Wiring Change –
Driver Seat Control Module –
Modification Instructions

MODEL 1997 MY
XK8 Range
VIN 001001-003300

ILLUSTRATION 1

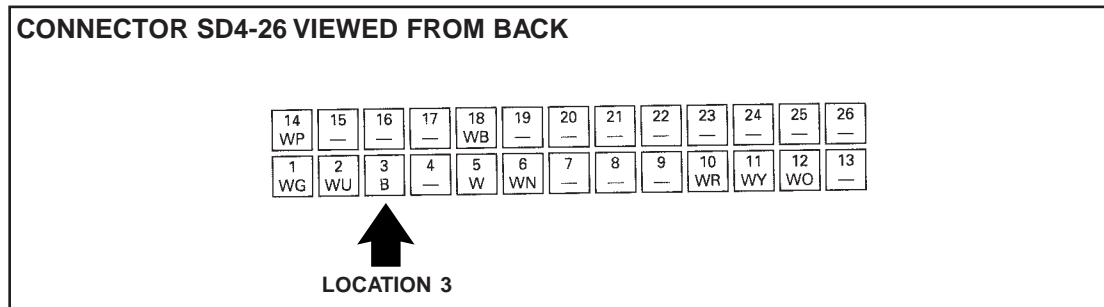
2. Disassemble the SD4/26 center connector to remove the black wire from location 3 (Illustration 1). Verify that the black wire is connected to body ground.
3. Reassemble the SD4/26 connector.
4. Remove the terminal from the black wire. Splice on a lead with a molex connector terminal already crimped on (part no. 418-083 supplied in the wiring harness repair kit 418-S065).
5. Pull out the red lock on connector SD5/10 to unlock the terminals.

ILLUSTRATION 2

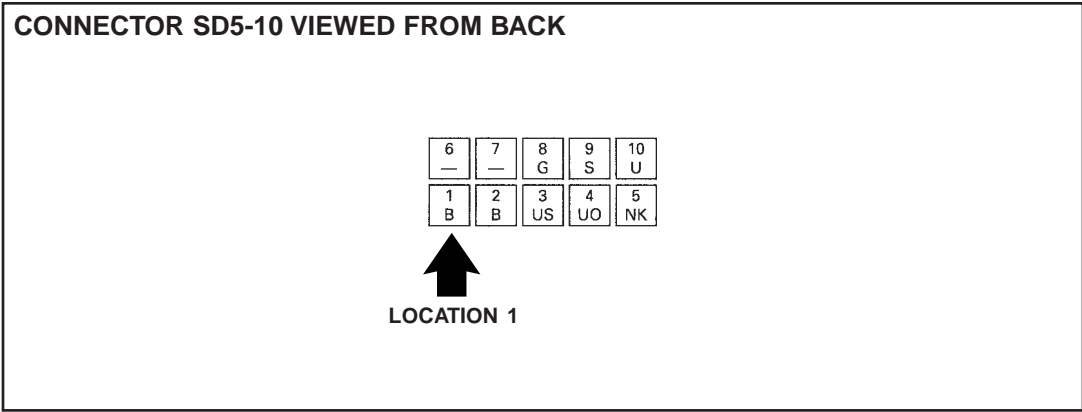
6. Install the new terminal that was joined to the black wire in position 1 on the SD5/10 connector (Illustration 2). Press the red lock back into position.
7. Connect and install the new DSCM.
8. Reconnect the battery.
9. Verify proper operation of all seat and memory functions.
